Union Carbide Corporation  
ATTN: Mr. H. E. Fritz, Operating Manager  
Sterling Forest Laboratory  
P. O. Box 324  
Tuxedo, New York 10987

Subject: Inspection 70-687/78-02

Subj: PROPOSED AMENDMENT TO SPECIAL NUCLEAR MATERIAL  
(SNM) LICENSE No. 639.

FIGURE 1

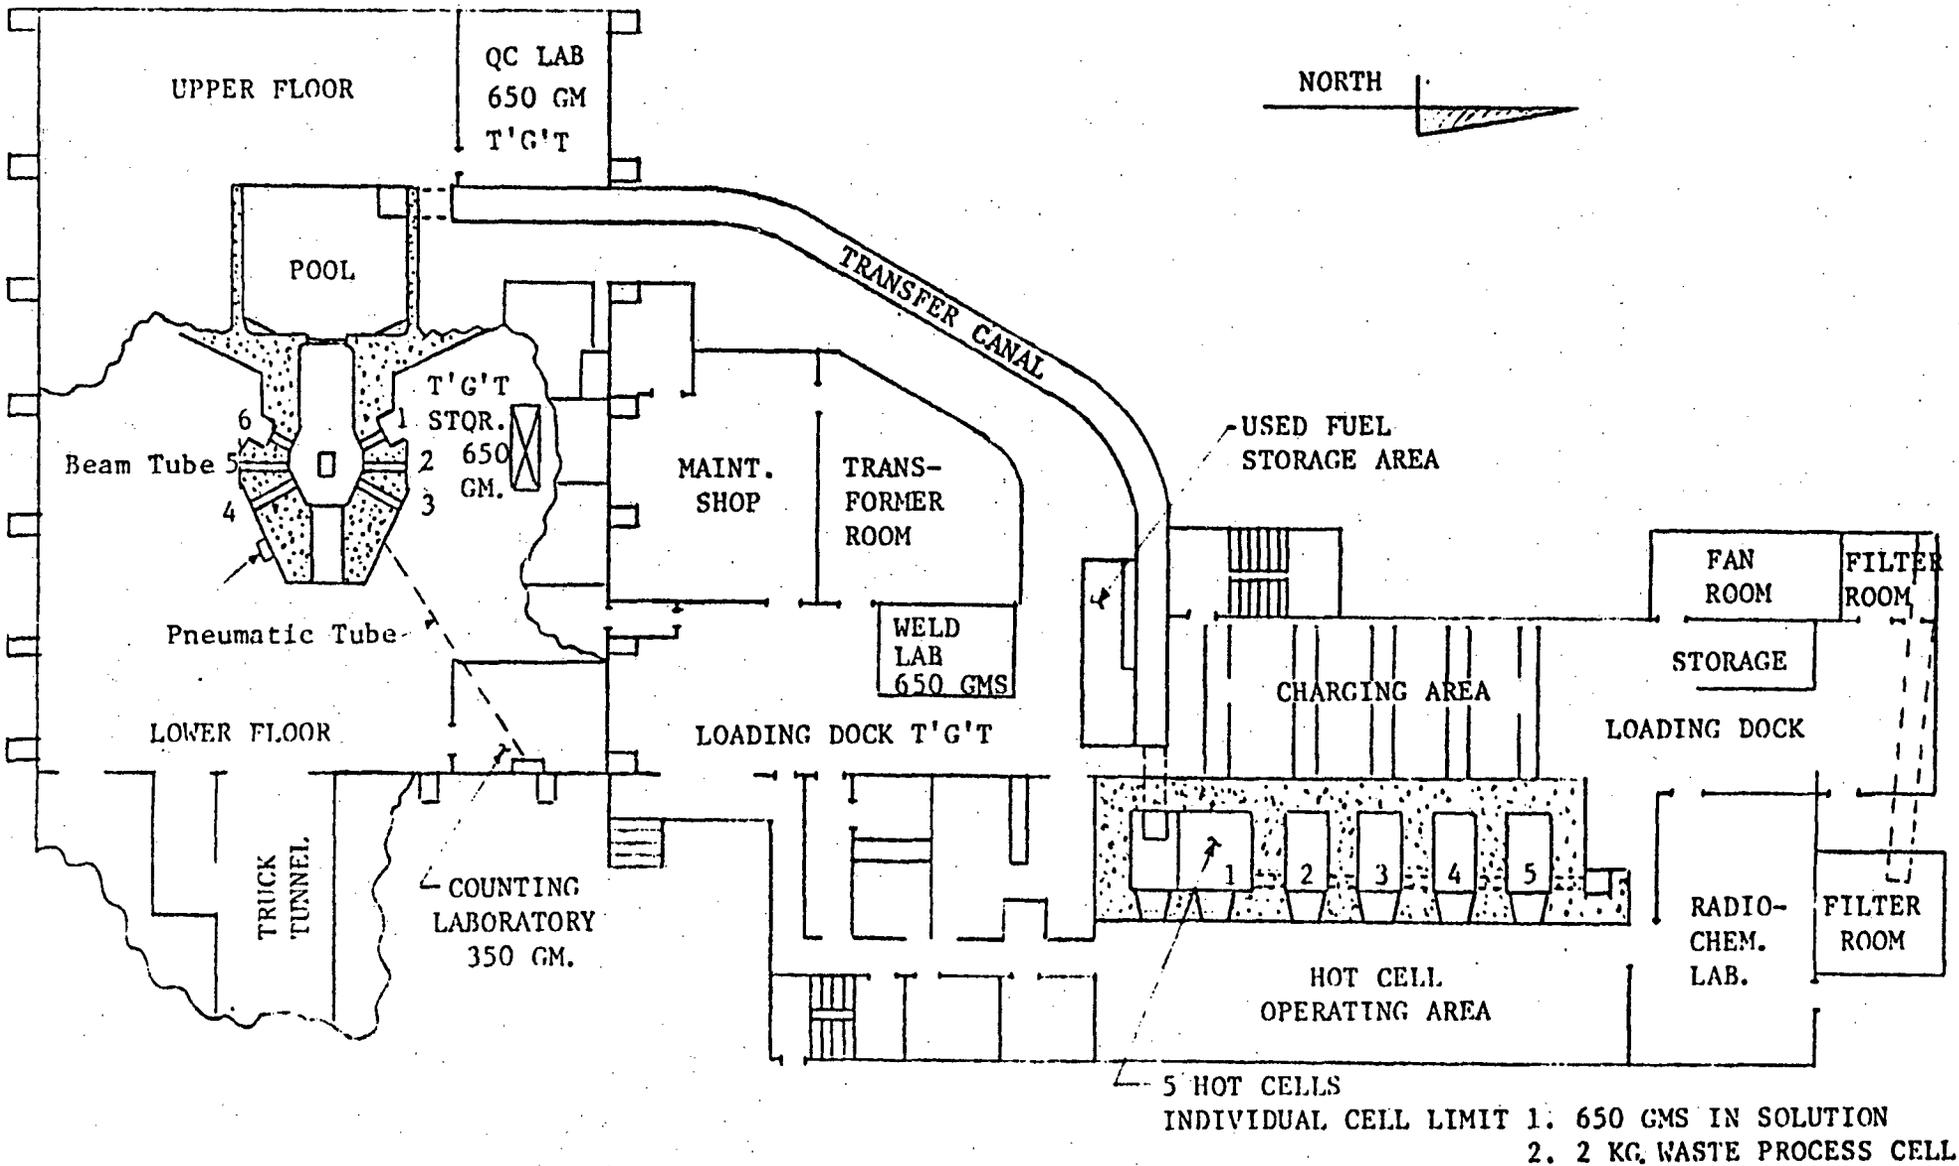
Revised floor plans are included to reflect the current storage locations and processing laboratories. A check in the amount of \$150.00 is enclosed to cover the administrative fee requirements of 10 CFR 170.31.

FIGURE 1A

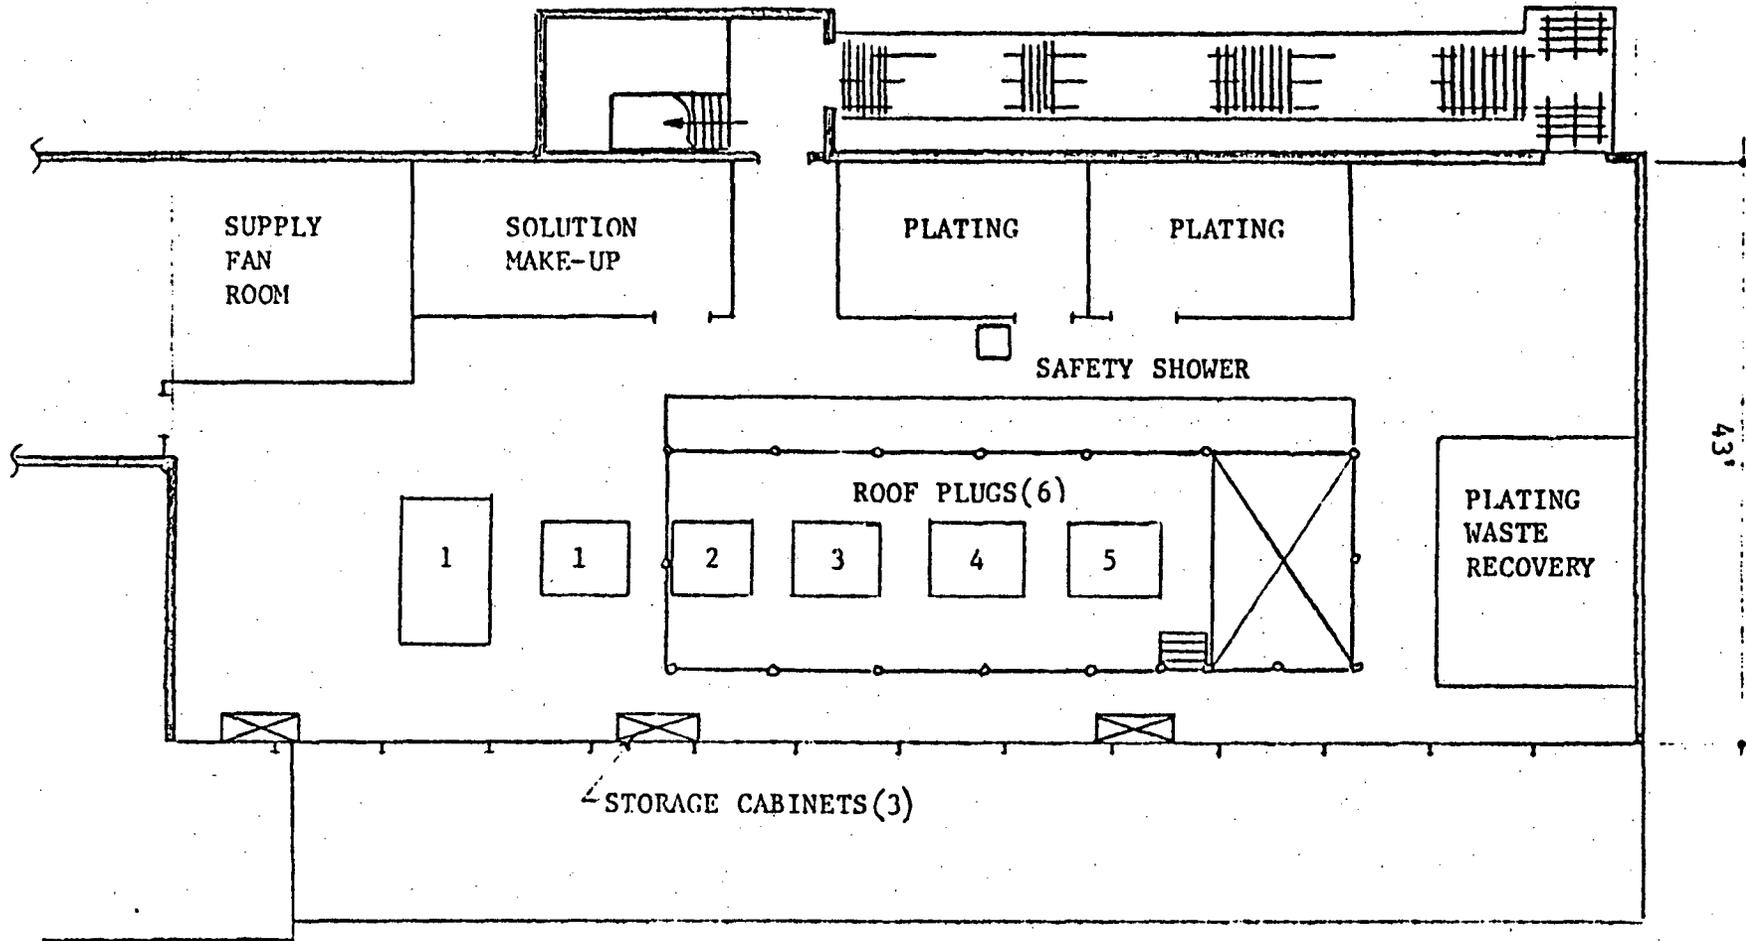
Uranium is stored in storage cabinets in the upper level of the hot laboratory (Fig. 1A). Material in liquid form is doubly contained. Storage cabinets are of fireproof construction, are separated by a minimum distance of three feet and are fastened to prevent inadvertent movement. All cabinets are locked and keys are in the custody of the SNM custodian for the area. Criticality control is implemented by limiting the quantity of SNM in solution to 350 grams per storage cabinet. This limit allows a safe margin below the single parameter limit of 760 grams U-235 in uniform aqueous solutions specified in the ANSI N16.1-1969 standard even

- "A.3. Unirradiated SNM in solution shall not exceed 350 grams in a single laboratory."
- "A.4. SNM, as an oxide, encapsulated for irradiation shall not exceed 650 grams in a single laboratory. When SNM is in process in the plating lab (Fig. 1A), it can be either as a solid (oxide) or in solution (electrolyte 15 gms/liter, H:U = 1500) and the quantity of either form shall be governed by the formula:

"A.2. All unirradiated SNM when not in use, shall be kept in locked steel cabinets which are located within a restricted area of the hot laboratory. The amount of U-235 in a single cabinet shall be limited to 350 grams in solution or 650 grams as  $UO_2$  or  $U_3O_8$ . The spacing between SNM storage cabinets shall be a minimum of three feet and each cabinet shall be fastened to prevent inadvertent movement. SNM in liquid form shall be doubly contained."
